# City of Eustis

TO: HISTORIC PRESERVATION BOARD

RE: REVISED CERTIFICATE OF APPROPRIATENESS 2022-COA-06 (NOW 2023-COA-05) CONSTRUCTION OF A NEW SHED AT 403 SOUTH MARY STREET (ALTERNATE KEY 1189977)

# EXHIBIT A: SITE PLAN

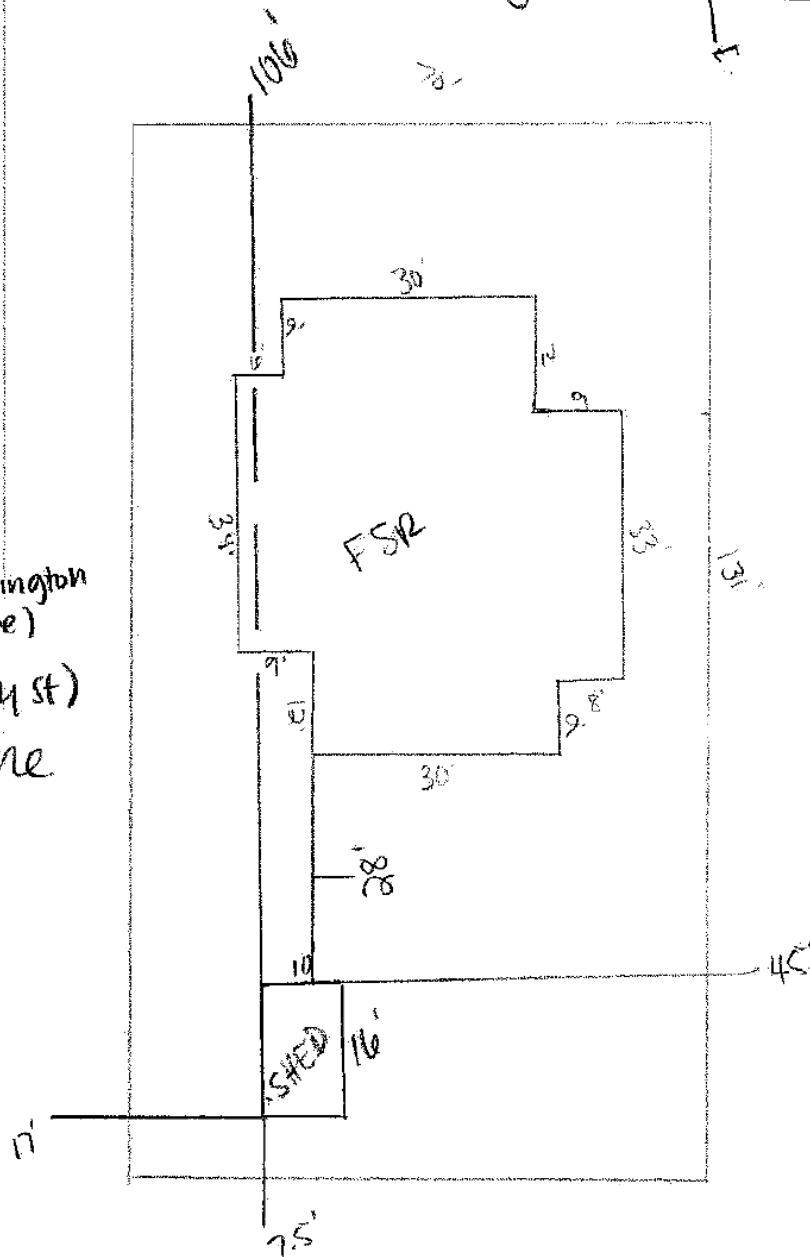
***The proposed setbacks are consistent with the requirements of the lot type and design district in addition to posing no issues with the relationship to the historic district and open space.***

EXHIBIT B: ELEVATIONS OF PREVIOUSLY PROPOSED SHED

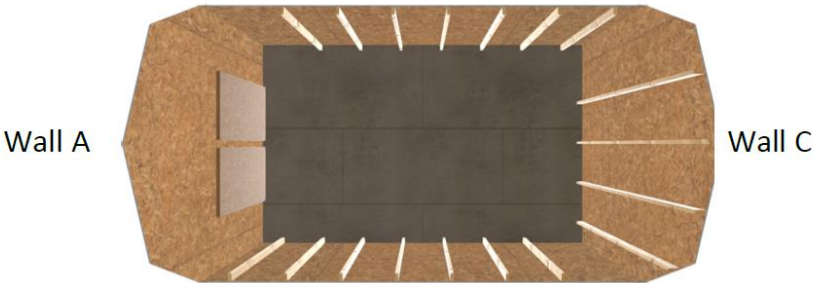
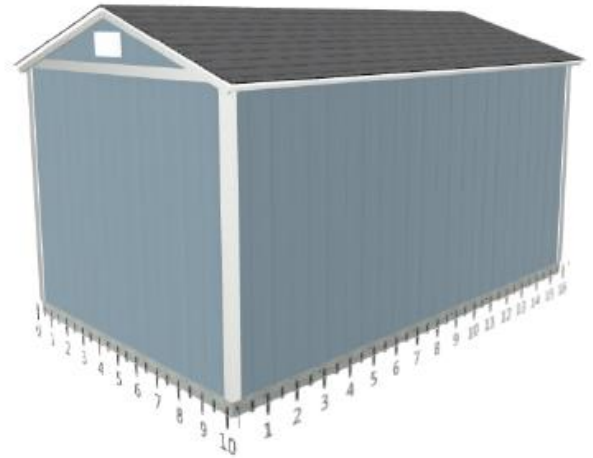
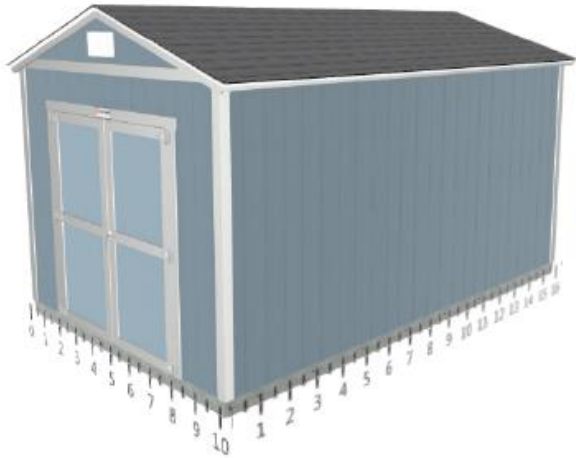
***The proposed shed is not shown to have features and colors to be consistent with that of the existing single-family home on the property. The color that is shown on the provided elevations is a similar color, but darker shade than the house appears to be. The proposed shed also does not have other features that would make it more consistent and compatible with the frame vernacular style.***

***The proposed color of the shed is not consistent with that of the current home on the site. The color that is shown on the provided elevations is a similar color, but darker shade than the house appears to be. The paneling on the proposed shed is vertical whereas paneling on the existing home is horizontal, so these two structures will lack some similarities with each other.***

***No windows are proposed to be as part of the shed, but the addition of windows, or even faux windows, would increase the suitability and agreeability with the frame vernacular architectural style. New windows could potentially be only added on the façade that faces the road and is visible to the public. In this style, double-hung sash windows are generally made of wood and spaced evenly along all facades. Windows can be single-pane, or 2- or 4-pane.***

***The pitch and style of the roof of the new, revised shed that is now proposed more closely match that of the existing single-family residence on the property.***

***The proposed shed not in the same color as the existing home, but the proposed color is similar. The proposed roof pitch is not consistent with that of the existing home nor the frame vernacular style.***

The proposed shed is not extensively consistent with the frame vernacular style, and staff would like to see greater effort, as discussed above, towards incorporation of frame vernacular elements as well as for the proposed shed to be more consistent with the existing home on site. Major elements that revision would be beneficial to on the proposed shed would be the color and windows as well as for siding to be horizontal as opposed to vertical.

staff recommends denial of this request until the applicant shows a greater consistency in their proposal.
